<u>Mercia.Liddle@westerncape.gov.za</u> | Tel: 021 483 4627 DEA&DP Reference: 16/3/3/6/7/1/D1/14/0217/24

CMU Reference: 17/1/8(CMU 090/2024)

RE: REQUEST FOR COMMENT FROM THE SUB-DIRECTORATE: COASTAL MANAGEMENT ON THE PRE-APPLICATION BASIC ASSESSMENT REPORT FOR THE PROPOSED EXPANSION OF MILKWOOD MANOR HOUSE AND PARKING ON ERF 10190, REMAINDER OF ERF 2066 AND REMAINDER OF ERF 706, PLETTENBERG BAY

(Figure 1 depicting the proposed property in relation to the CML as well as the development island around Erf 10190)

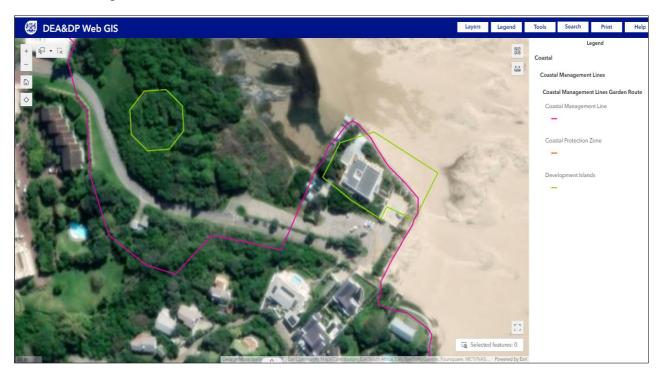
- 2.1.6. In Appendix A2 (Coastal Risk Lines) the applicant identified the subject properties in relation to erosion risk lines. In terms of coastal risk modelling commissioned by the SD: CM, Erf 10190 is located landward of the Garden Route District coastal management line ("CML") and is also a development island. Erven RE/2066 and RE/706 fall partially seaward of the CML (see Figure 1 below). The technical delineation of the CML was to ensure that development is regulated in a manner appropriate to risks and sensitivities in the coastal zone. The CML was informed by various layers of information including biodiversity, estuarine functionality, risk flooding, wave run-up modelling, zoning, inter alia and was delineated in conjunction with and supported by other organs of state including Local and District municipalities as well as CapeNature and all other organs of state represented on the steering committee for the Garden Route District CML project. The principal purpose of the CML is to protect coastal public property, private property, and public safety; to protect the coastal protection zone; and to preserve the aesthetic value of the coastal zone. The use of CMLs is of particular importance in response to the effects of climate change, as it involves both the quantification of risks and pro-active planning for future development.

2.1.7. Be advised that a development island is considered outside or landward of the CML in order to recognise existing development rights. In this regard, all the proposed activities within the boundaries of Erf 10190 falls within the development island and thus landward of the CML. Furthermore, all proposed activities directly south of Erf 10190 are also considered landward of the CML (see Figure 1 below). However, it must be noted that the development islands is to limit the enhancement of existing development rights and/or the expansion of development within these development islands in order to reduce risk of human life and properties as a result of coastal processes and impacts of climate change.
